NJSEA Lyndhurst Roof Replacement

Bid Due Date: October 7, 2021 @ 3:00PM

ADDENDUM #1

Attachments:
Crane.Logistics Plan

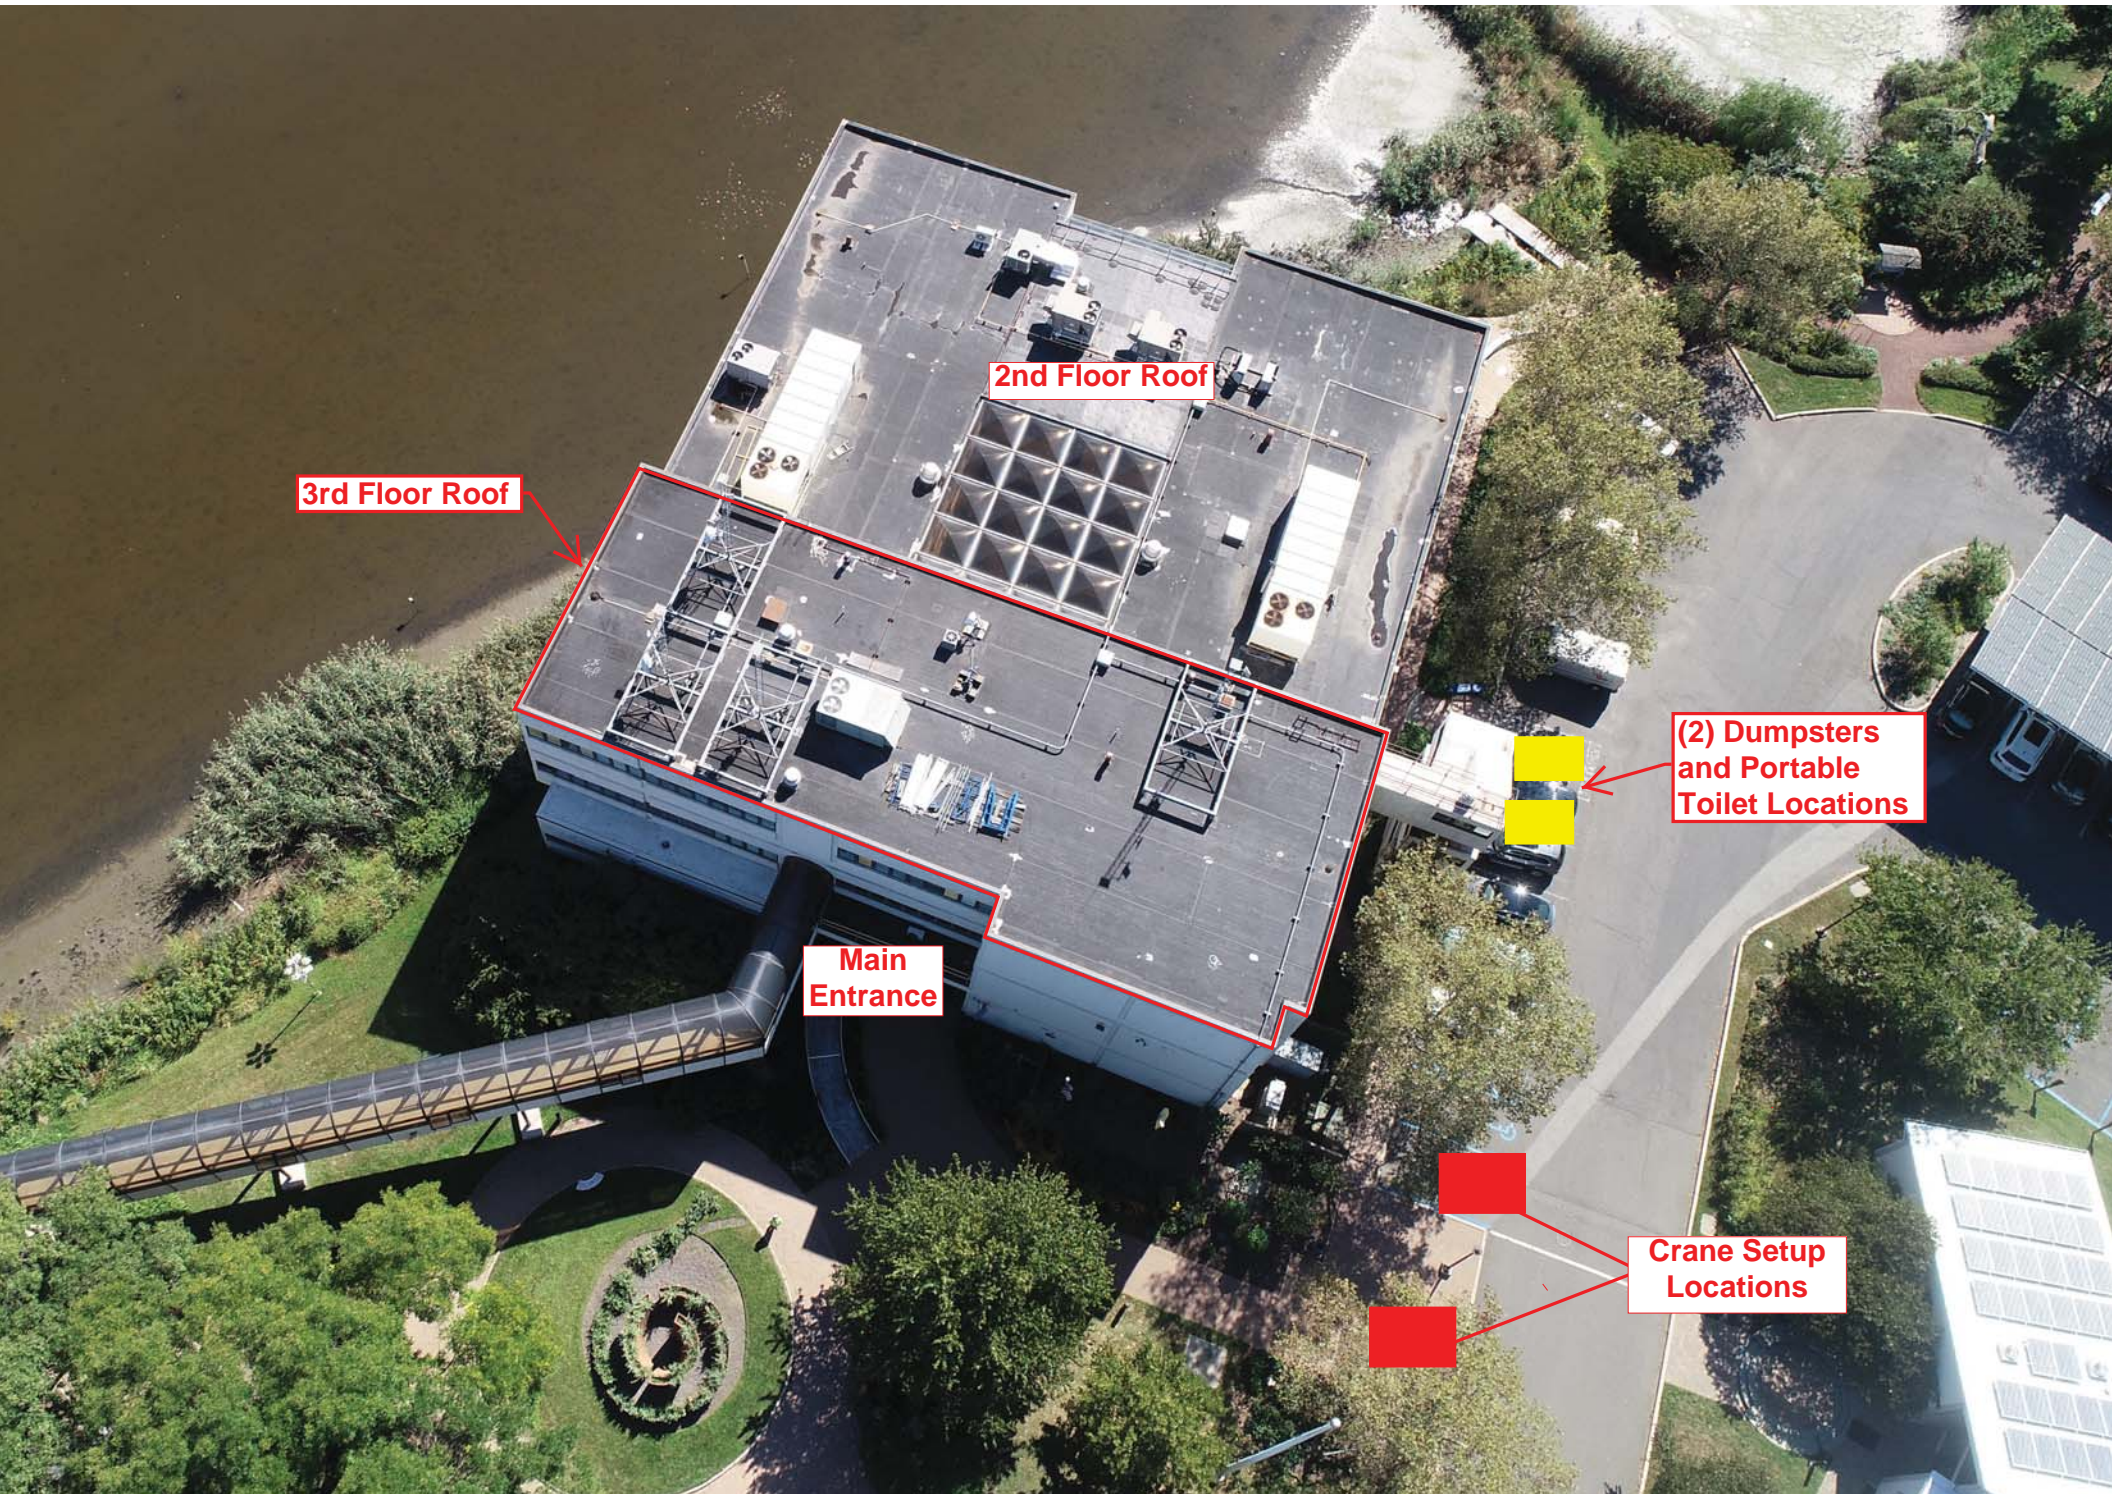
- A. The Bid walk summary is incorporated with the changes below and should be included in the bid pricing. Changes included in this bid walk:
 - i. Relocation of the scaffolding on the roof will be handled locally.
 - ii. Roof access shall be by a ladder to the 2nd floor roof on the exterior side of the building by the visitors parking.
 - iii. Provide roof protection on the 2nd floor roof from the ladder to the 3rd floor ladder as well as to the chute. Protection required will be 3/4" plywood on 1" insulation and weighted down for wind uplift.
 - iv. Portable toilet and the two (2) dumpsters to be located at the side entrance by the visitors parking.
 - v. Dumpsters and chute shall be enclosed with a tarp at all times.
